From: [Paul Lotakis](#)
To: [PCD; David Greetham](#)
Cc: [cheryl Coon](#)
Subject: Wysong/Ziemba Dock Proposal-Little Manzanita Bay
Date: Friday, March 13, 2020 5:52:16 PM
Attachments: [IMG_5289 3.PNG](#)
[IMG_5294 2.PNG](#)

I am writing in reference to the application and proposal to construct a 240 foot dock on Little Manzanita Bay.

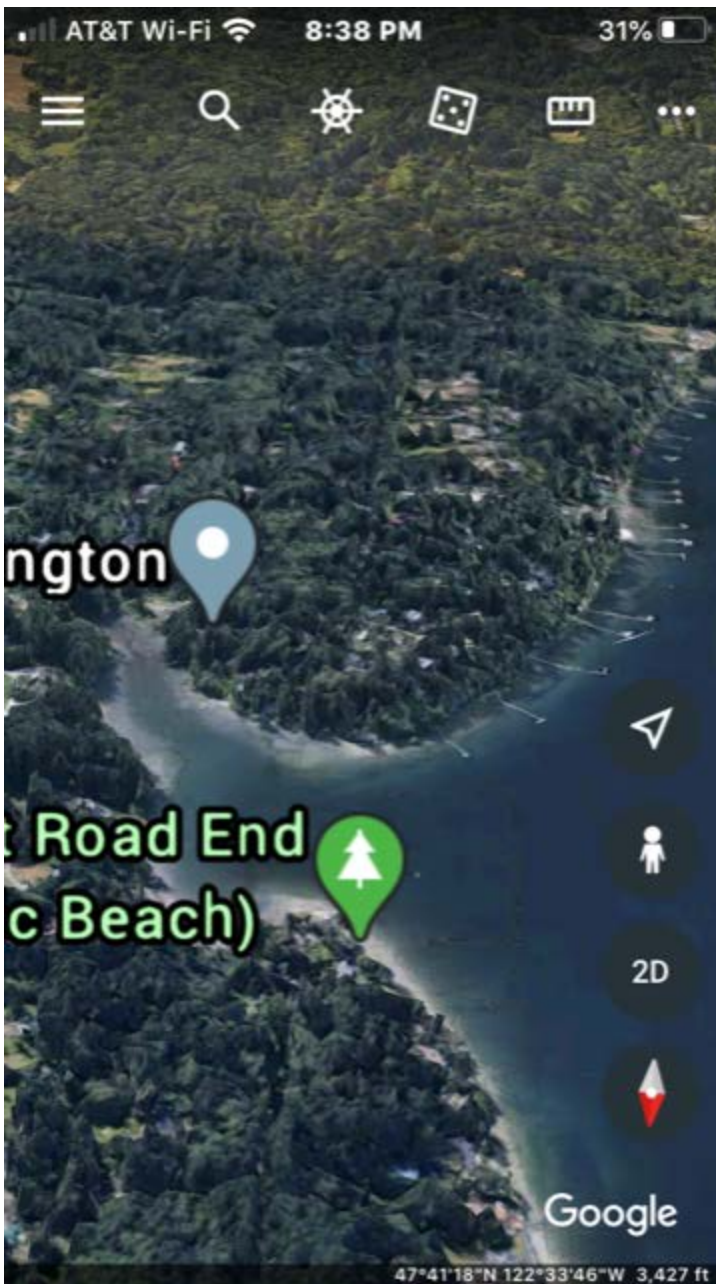
I request that the Planning Department examine the geography of the two bays, using Google Earth, to see the impact on Little Manzanita Bay and the neighbors and visitors that use the bay. They say one picture is worth a thousand words and a greater aerial overview will reveal what the schematic and plan proposals of the application do not show. Consider this dock will be over half the length of a super jumbo ferry (460 ft). This dock would also be nearly a third of the length of the mouth of the bay and completely out of scale for a cove of this size.

To reiterate, I believe the size and scope of this project is inappropriate for Little Manzanita Bay.
